## **IMPORTANT SAFETY RECALL**

This notice applies to certain 2018-2019 Load Trail Tandem and Triple Axle Dump Trailers with 621-scissor hoist option

NHTSA Recall Number: 19V-279

## Load Trail 621-Scissor Hoist Repair Procedure

Diagram N-1.0

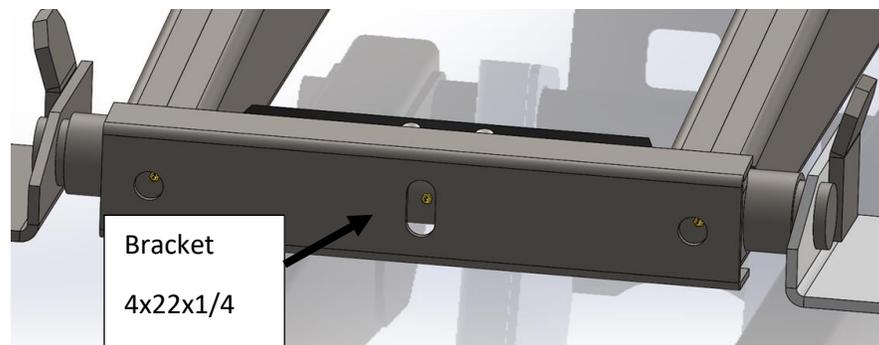
1. Lift the dump body following the instructions in Section 5.6 (Body Prop) of your Load Trail owner's manual.  
*\* DO NOT enter the area under a raised dump body without first supporting the empty dump body up with the body prop. \**
2. Lower dump body onto the body prop.
3. Begin the installation of the 621-Scissor Hoist repair kit by first welding the (4 X 22 X 1/4 Bracket) to the outer scissor arms of the 621-Scissor Hoist. There should be a weld on the top and the bottom of both outer scissor arms. (See diagrams N-1.0 and N-1.1)
